TREATABILITY STUDY WORK PLAN ZONE K SOLID WASTE MANAGEMENT UNIT 166  
(SWMU 166) CNC CHARLESTON SC  
3/1/1999  
ENSAFE

**ZONE K  
SWMU 166 TREATABILITY STUDY  
WORK PLAN**

**DRAFT ZONE K  
SWMU 166 TREATABILITY  
STUDY WORK PLAN**

## **SWMU 166 Treatability Study Work Plan Comments/Response to Comments**

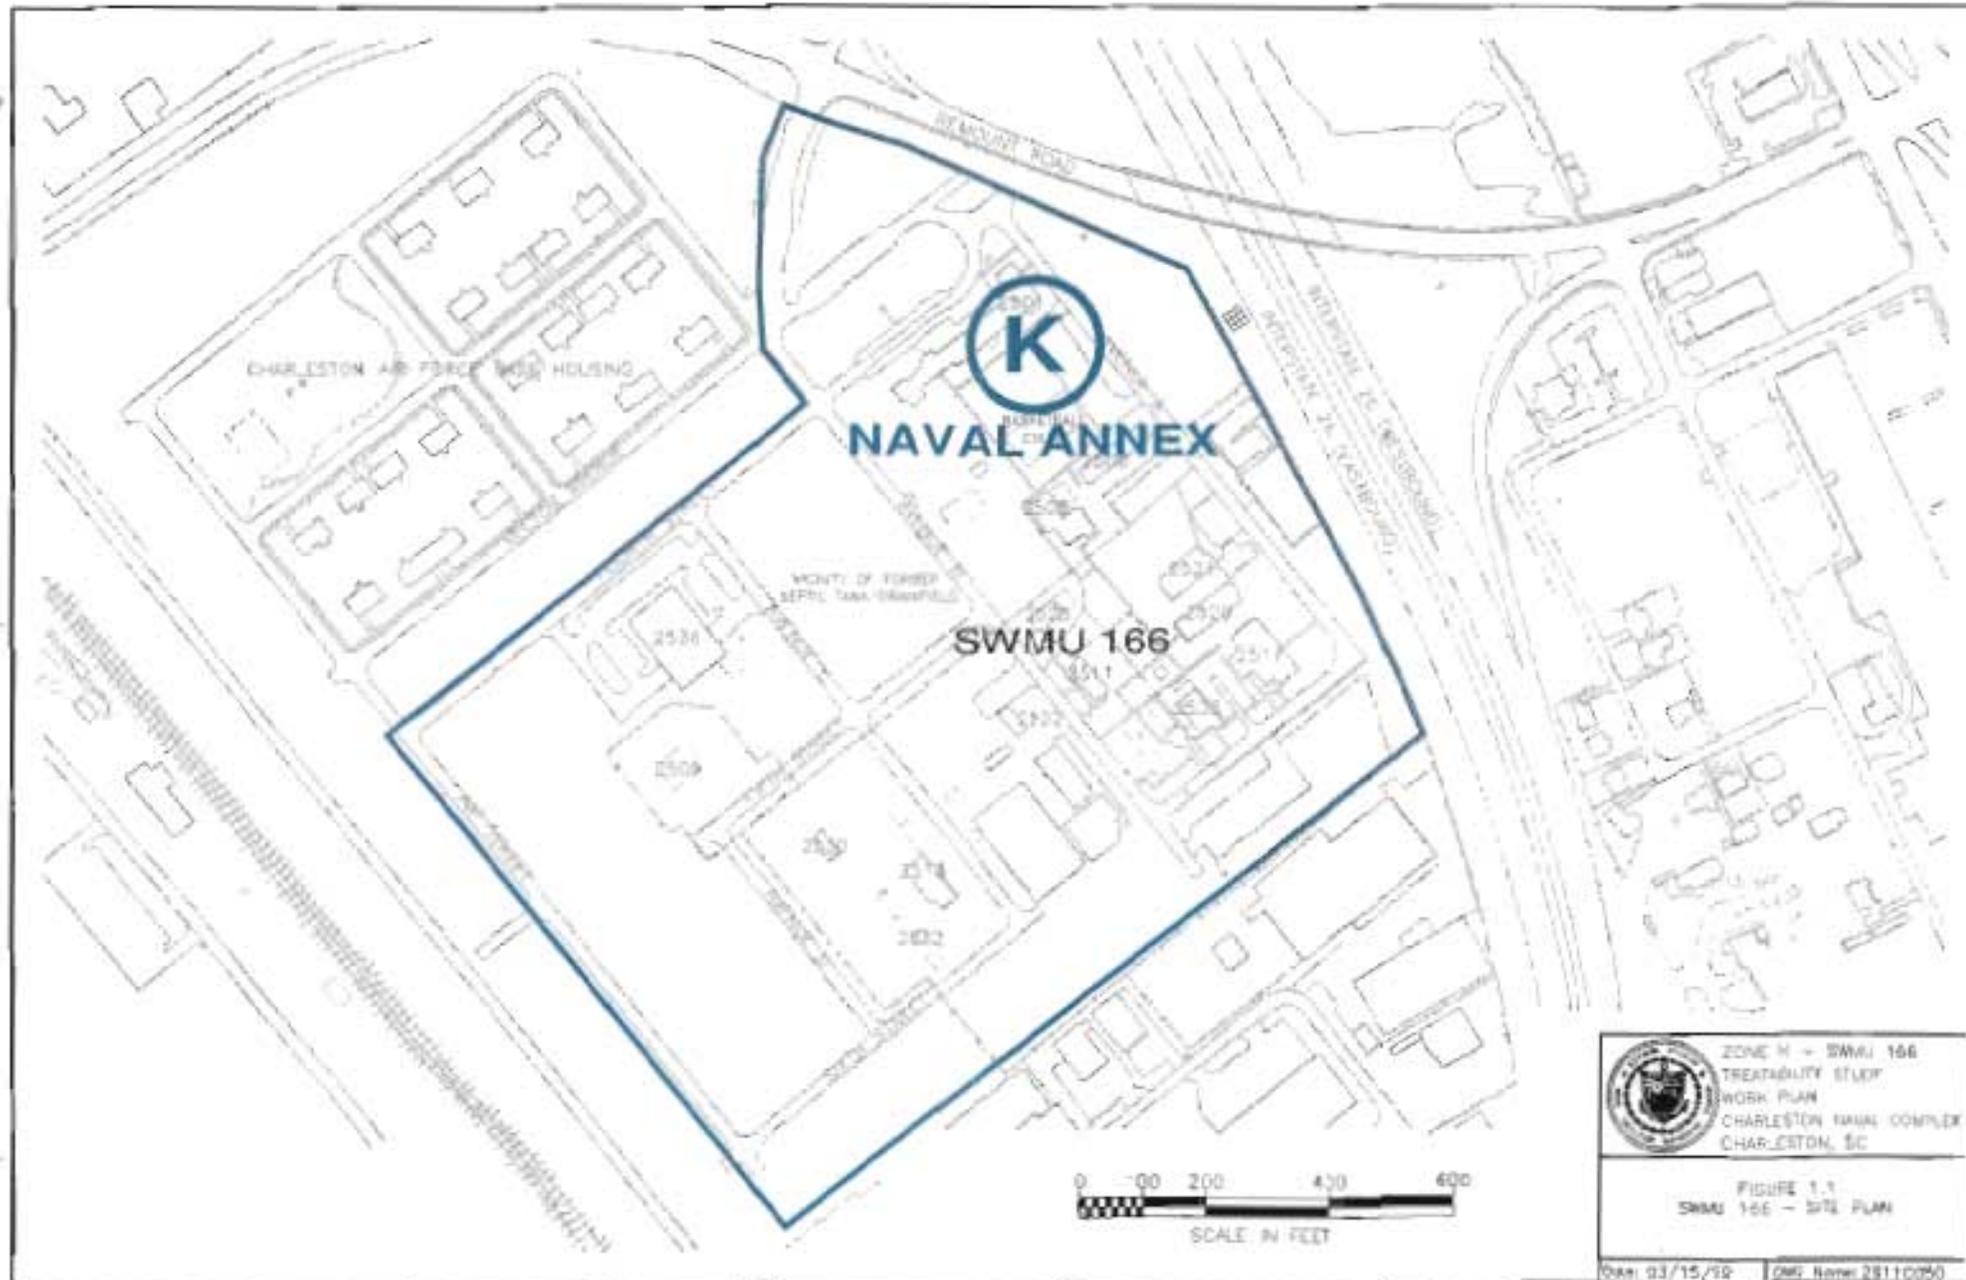
Figures 1.2 and 1.3 ... these figures are not complete, fill material is shown, what fill material?, litho as presented appears homogeneous, legend does not match figure symbols, is this a Zone F cross section?, does this consider the most recent data available? Please correct to accurately portray site cross-section conditions.

**Figures 1.2 and 1.3 has been replaced by a figure taken from the Zone K RFI (Figure 2.5). This figure differentiates between the upper and lower units of the shallow aquifer and provides greater detail than the figure presented in the draft TS WP.**

Figure 1.5  
 Shallow Groundwater  
 Potentiometric Map  
 January 1999

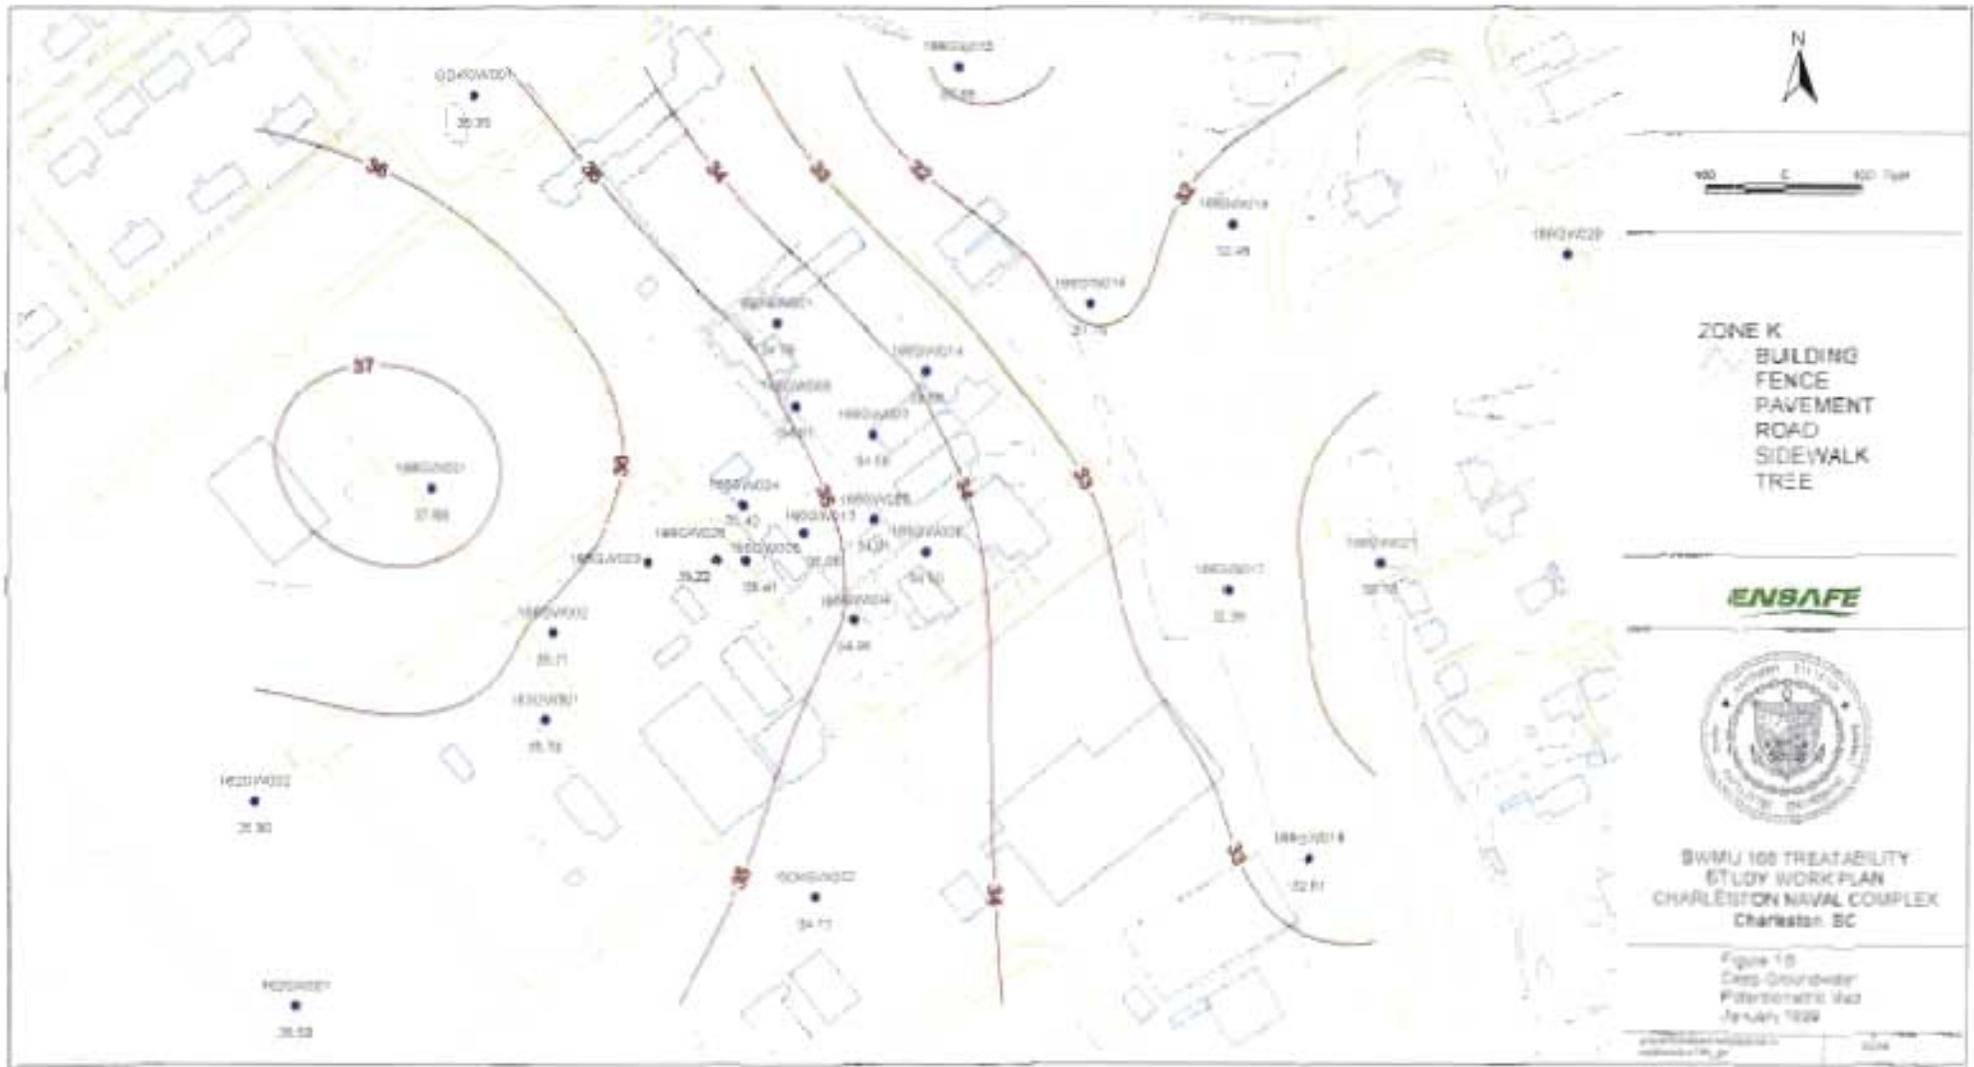
Figures 1.4 and 1.5 ... we would like to see more (and most recent) potentiometric contours ...

is the GW flow direction, as shown in the TS, constant and representative of current site conditions?

**Figures 1.4 and 1.5 have been renumbered to Figures 1.3 and 1.4. Additional potentiometric maps were generated using data collected in January, 1999. This data has been contoured and is shown on figures 1.5 and 1.6.**

**There are currently no other sets of water level data collected from a sufficient quantity of wells within a close enough space of time to produce representative contours. However, additional water level data will be collected prior to beginning the AA sequencing study to further assess seasonal fluctuations in groundwater elevations. Water levels will also be monitored during system start-up to assess changes in potentiometric surface due to the extraction and injection wells. Details of the water level monitoring events will be provided in the O&M plan submitted as part of the design document.**
